**Re: 49 CFR Part 573; Recall of Mercedes-Benz CLS**

TO: Mercedes-Benz Dealer Principals, General Managers, Sales Managers, Service Managers, Parts Managers	FROM: Thomas Brunner, Department Manager, Vehicle Compliance and Analysis, Engineering Services
RE: : Recall Campaign 2012110003 – <b>Retorque the Engine Hood Latch Striker, Model 218 (CLS), Model Year 2012</b>	DATE: November 21, 2012

SUBJECT: **Model 218**  
**Model Year 2012**  
**Retorque the Engine Hood Latch Striker**

**Figure 3**

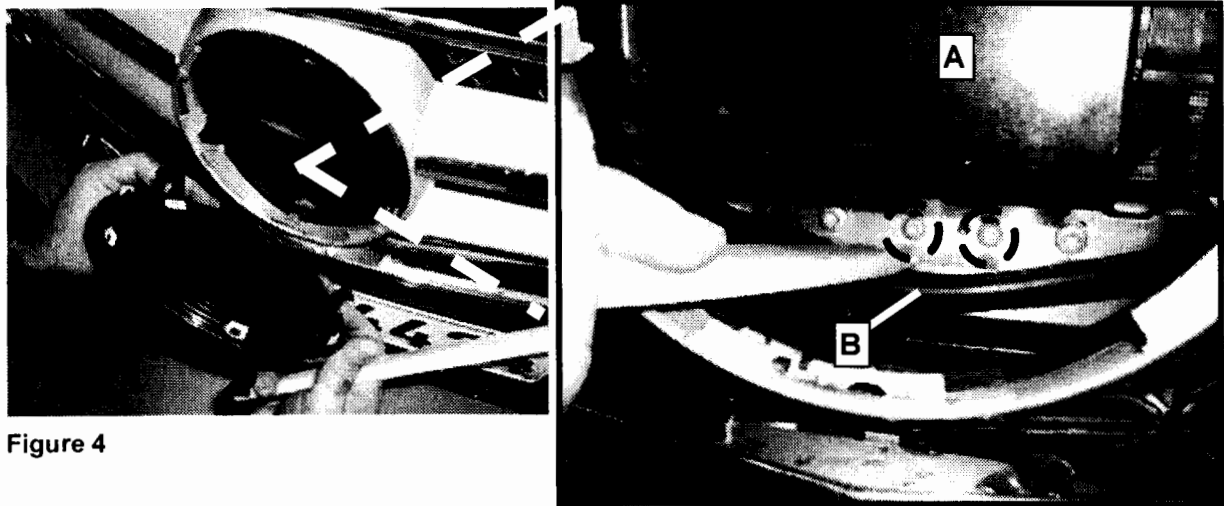
This Recall Campaign has been initiated because Daimler AG (DAG), the manufacturer of Mercedes-Benz vehicles, has determined that due to incorrect technical documentation, the bolts securing the striker for the engine hood latch might have been tightened with reduced torque in the subject vehicles. The engine hood is secured with one lock on the left side and one lock on the right side. If only one of these locks is engaged, the engine hood will remain safely secured. If the engine hood is not properly closed and both locks are not engaged, an additional securing mechanism is provided by the engine hood latch. The driver is made aware of this condition by a warning message in the instrument cluster indicating the engine hood is not properly closed. If the driver were to disregard this warning message and if at least two bolts of the striker for the engine hood latch are loose, the engine hood has no securing mechanism and could open while driving, thus increasing the risk of a crash.

3. Retorque 4 bolts (Circled, Figures 3 and 4) of engine hood striker to: 10 Nm.

Lower striker bolts (circled, Figure 4) are located below Distronic sensor (A) behind rubber hose (B).
